**Re: Ontario Energy Board (OEB) Staff Clearspring Evidence Interrogatories  
Hydro One Networks Inc. (Hydro One)  
2023-2027 Joint Rate Application (JRAP)  
OEB File Number: EB-2021-0110**

**HYDRO ONE NETWORKS INC.**  
**2023-2027 JOINT RATE APPLICATION**

**OEB STAFF CLEARSPRING EVIDENCE INTERROGATORIES**

**November 10, 2021**

**Figure 4 Hydro One Distribution Total Cost Benchmarking Results**

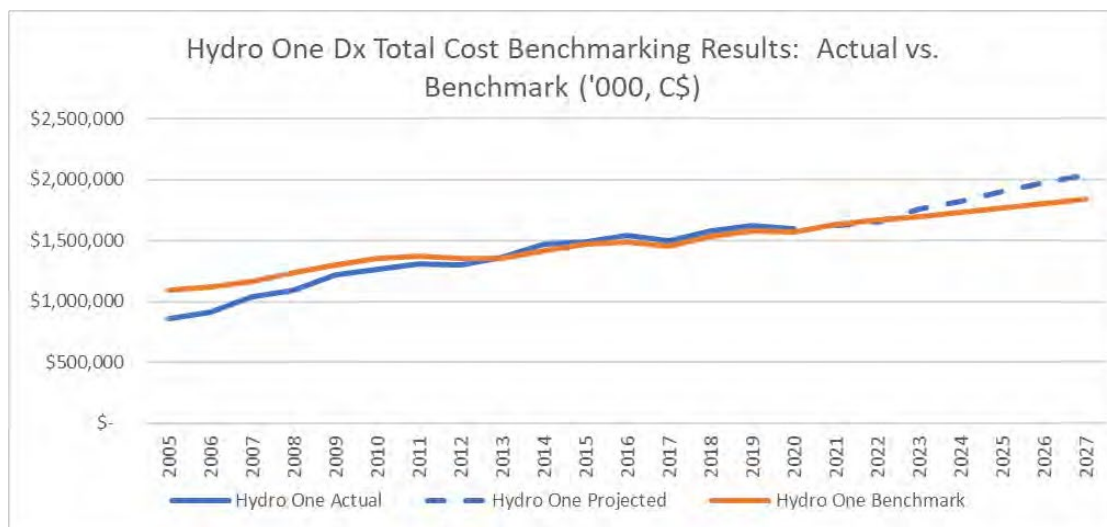
Examination of the orange line (Hydro One benchmark) in Figure 4 shows it above the blue line (Hydro One actual) in the early years (2005 to about 2012) but below the blue line (Hydro One actual and projected) in the latter period (starting around 2020-2022 and through the 2023-2027 plan period), and pivoting in the middle. It appears that the difference between Hydro One actual/projected and the benchmark line could be accounted for by allowing the Trend variable to have a different coefficient for Hydro One than for the U.S. utilities in the sample.

- a) Did Clearspring examine the possibility of a different time trend coefficient for Hydro One in its analysis?
- b) What is the basis, both theoretical and empirical, for Clearspring assuming that the time trend variable is the same for Hydro One and all U.S. utilities?
- c) What analysis did Clearspring conduct to test the hypothesis that the time trend coefficient should be the same for all of the U.S. utilities in its sample?
- d) While noting that time trend variables are frequently included in these models, Clearspring has not provided any explanation as to what temporal changes in the business conditions of the sampled utilities the time trend variable is proxying. Please provide additional explanation, with support, for the inclusion of the time trend variable, and why it might have a different slope (coefficient) compared to the sample of U.S. utilities.
